SUNDRY NOTICES AND REPORTS ON WELLS

8. Well Name and No.
Gulf Federal #39. API Well No.
30-015-2526510 Field and Pool, or Exploratory Area
Brushy Draw Delaware11. County or Parish, State
Eddy, New Mexico

RE: Plugging and Abandonment Requirements, Conditions of Approval

Wellbore Diagram**Well ID Info:**

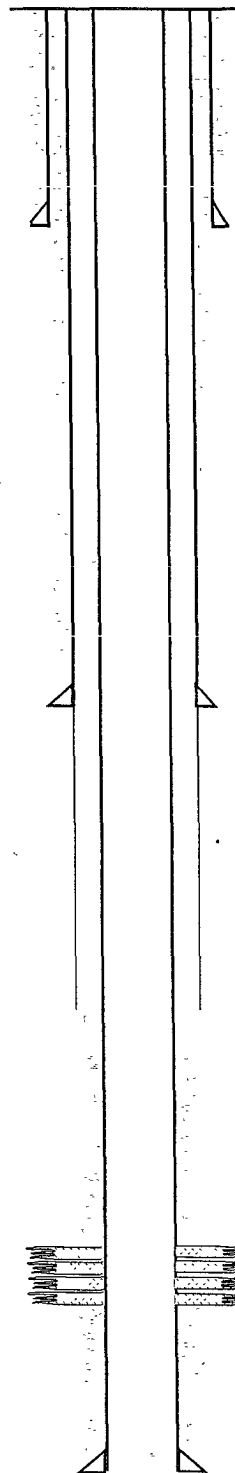
1. Notify BLM 24 hrs prior to MI and RU.
2. RIH set CIBP at 5200', spot 25sx plug of class "H" cement from 5200'-5000' (perfs).
3. Displace hole w/MLF, 9.5# Brine w/25# gel P/BBL.
4. Perf 4 holes at 3250', sqz 100sx cement from 3250'-2850' (shoe/B.salt). WOC Tag.
5. Perf 4 holes at 1100', sqz 50sx, plug from 1100'-900' (T-Salt estimated) WOC Tag.
6. Perf 4 holes at 400', sqz 130sx, plug from 510'-surface (shoe/Fr.Wtr./surface) WOC Tag.
7. Install dry hole marker.

1. OK
2. OK (Perfs)
3. OK
4. OK (Delaware – BOS – Casing shoe)
5. Move plug to 800'-600' – Otherwise OK (TOS)
6. Perf holes at 510 – Otherwise OK (Casing shoe – Surface)
7. OK – Verify cement to surface in all annuluses.
8. Submit a subsequent report to the BLM.
